PLANNING AND DEVELOPMENT SERVICES STAFF REPORT

For Planning Commission Meeting of September 9, 2015

**SUBJECT: 2250 Ann Arbor-Saline Road Site Plan and Wetland Use Permit for City Council Approval
(2250 Ann Arbor-Saline Road)
File Nos. SP14-023 & WUP15-001**

2250 ANN ARBOR-SALINE ROAD
 SITE PLAN
 DIMENSIONAL SITE PLAN

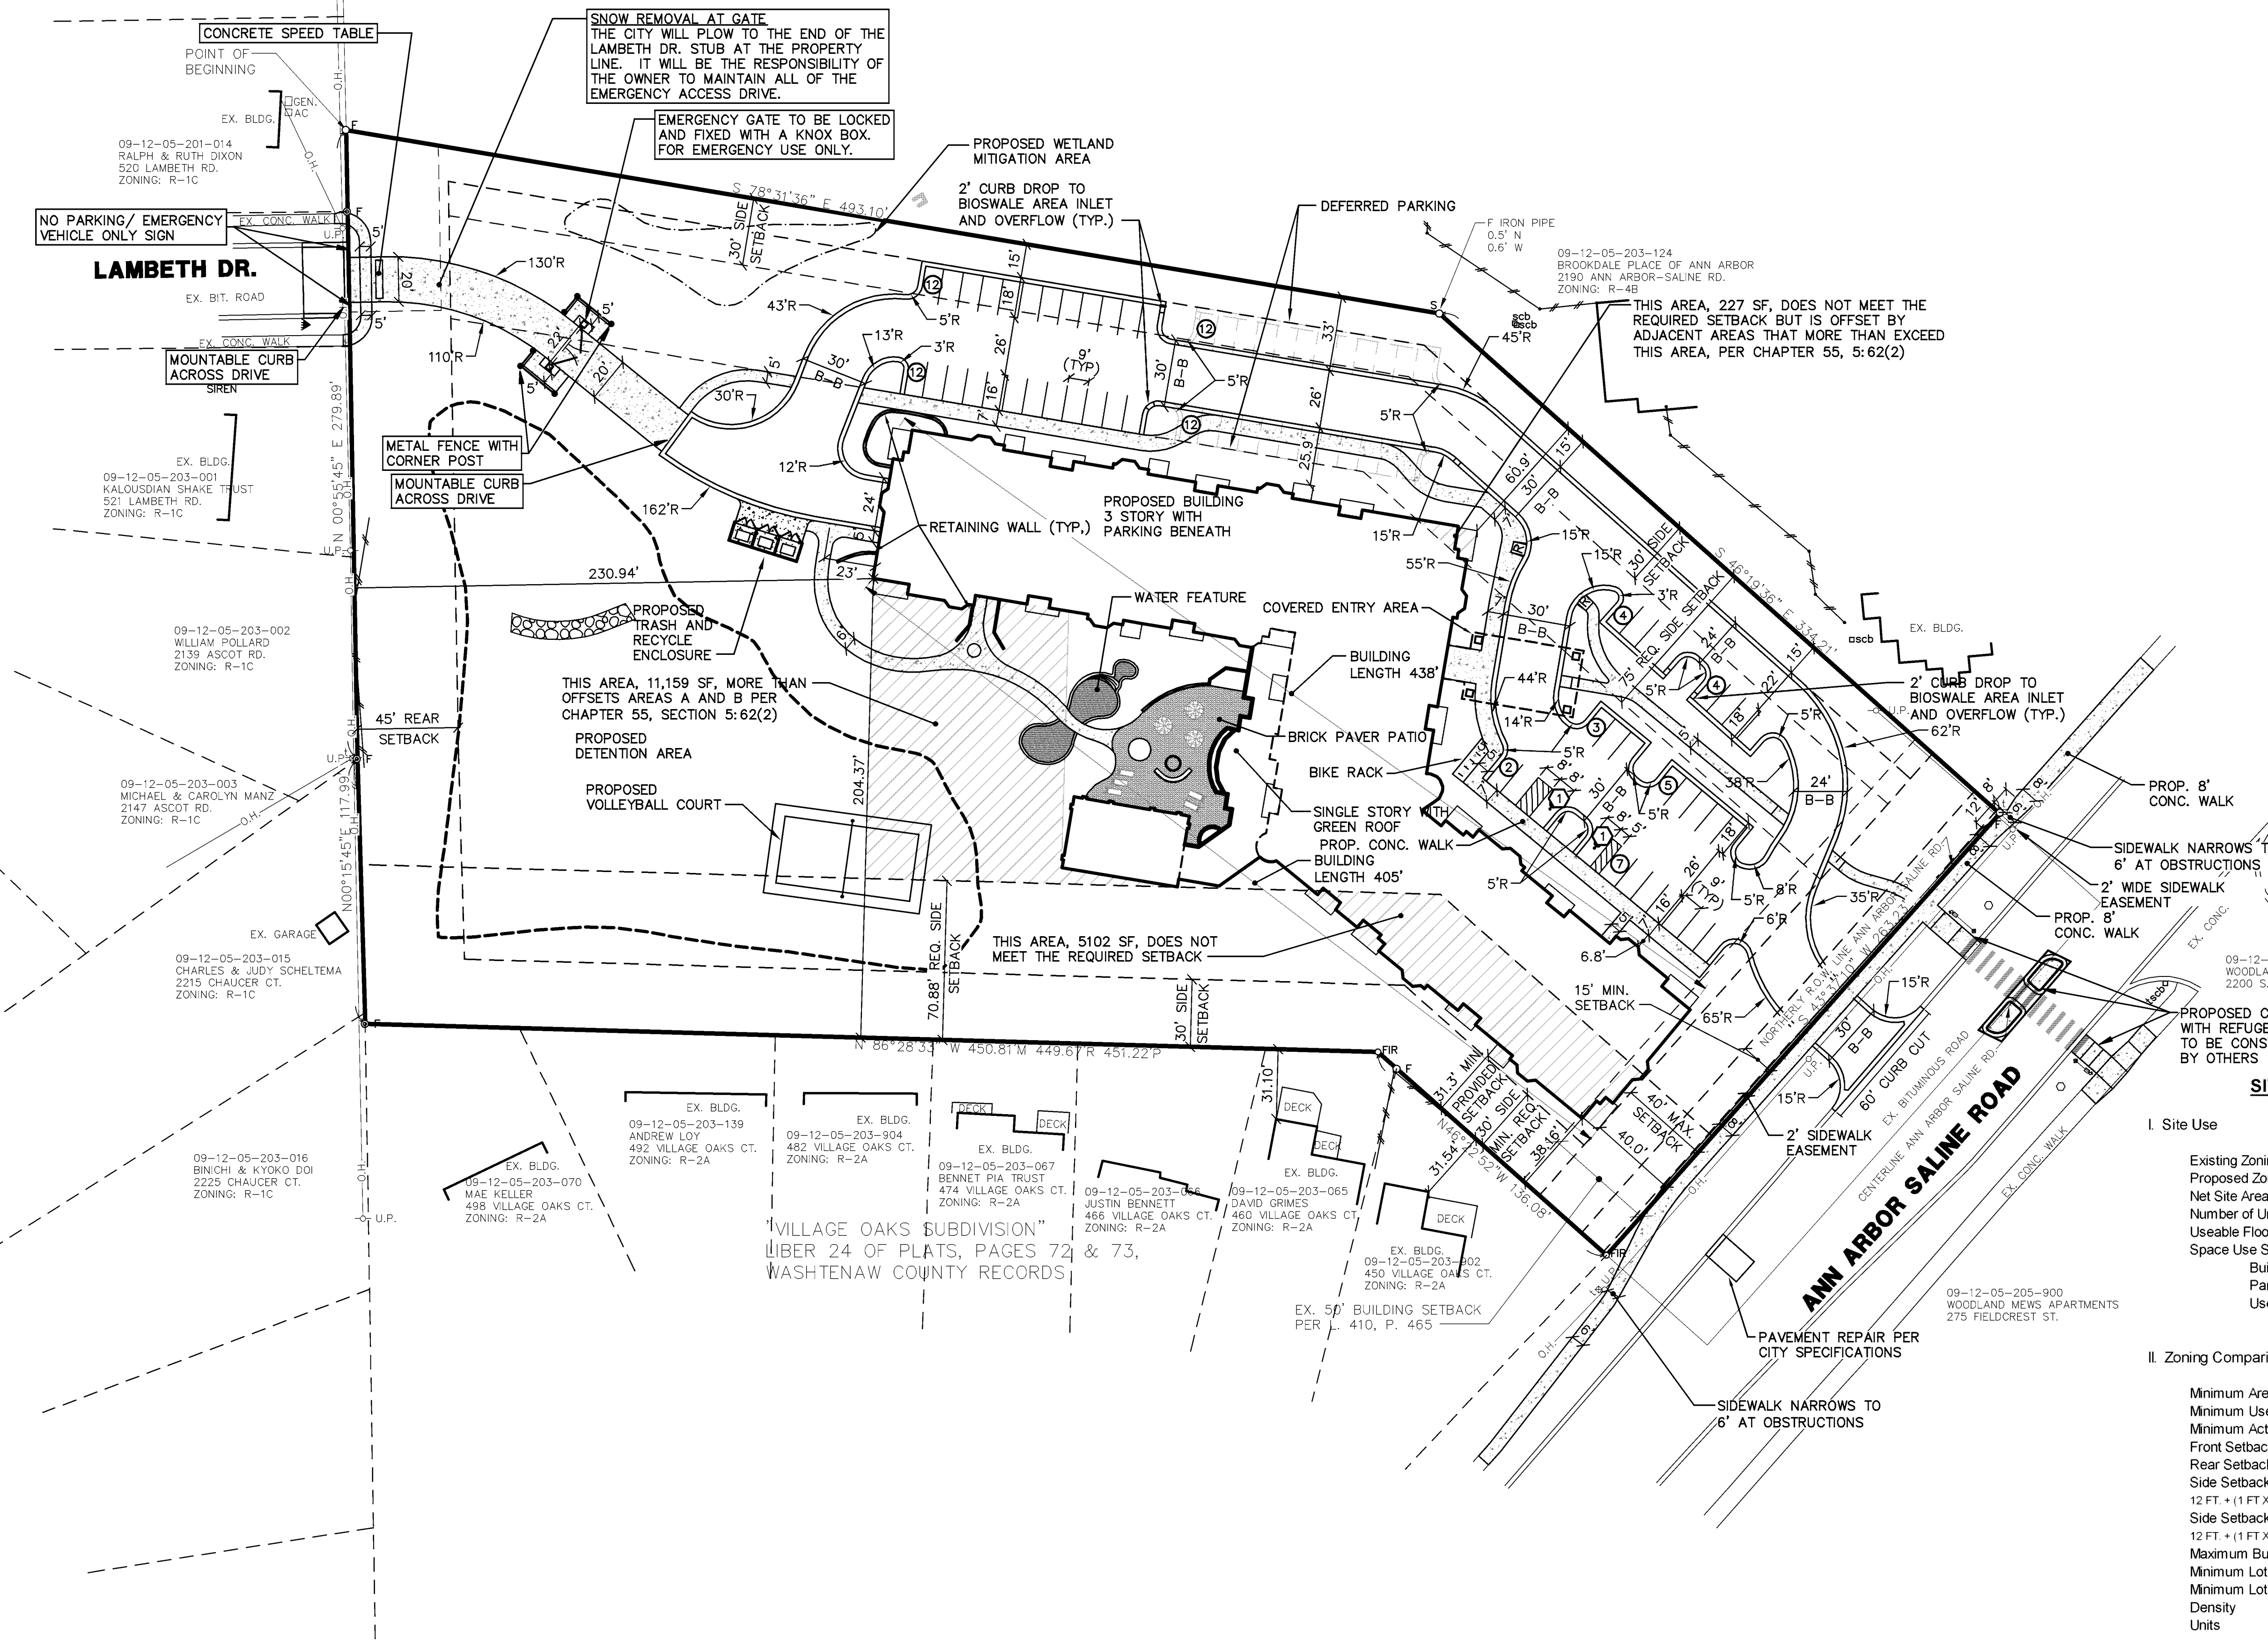
Access to Lambeth Drive – Planning Commission expressed concern about the previously proposed emergency-only gated connection to the adjacent neighborhood using the existing Lambeth Drive stub street, but indicated general support for the concept of the emergency access only drive. The petitioner has responded by converting the former 30 foot wide asphalt drive with sidewalks on both sides to a 20 foot wide concrete path, similar to an extra-wide sidewalk as suggested by Planning Commission. The path will have a rolled curb at both ends, sidewalks that 'carry through' the path at the Lambeth terminus and a concrete speed table to further delineate the path from a standard drive.

The path will still have a locked gate for emergency access only, but will have a pedestrian sidewalk bypass around the locked gate with a metal fence adjacent to prevent vehicular use. The gate will remain locked with a Knox Box for use by emergency services only. Residents of the development will not have a key, only the fire department. The locked gate will be shown on the approved site plan and removal of the gate for facilitation of general public access will be a violation of the site plan and enforceable against the property owner. This requirement will also be listed in the site development agreement, which is a legally binding document between the City and the property owner.

Parking – Planning Commission expressed concern about the number of surface parking spaces provided on the site. The petitioner has agreed to defer 24 surface parking spaces near the northeast corner of the building. These spaces will be shown on the site plan as deferred, but storm water and landscaping calculations are reviewed as if the parking will be installed. Chapter 59 (Off-Street Parking) allows that if the Planning and Development Services Manager or designee determines that the parking is needed, the spaces must be installed. There will be no Planning Commission approval required if the spaces are installed in the future.

Sidewalk connection – The location of the sidewalk serving the interior of the site has been adjusted to line up directly with the newly installed crosswalk and pedestrian island on Ann Arbor-Saline Road.

Indoor pool building – The building containing the indoor pool has been adjusted approximately three feet to the north out of the additional required setback area.
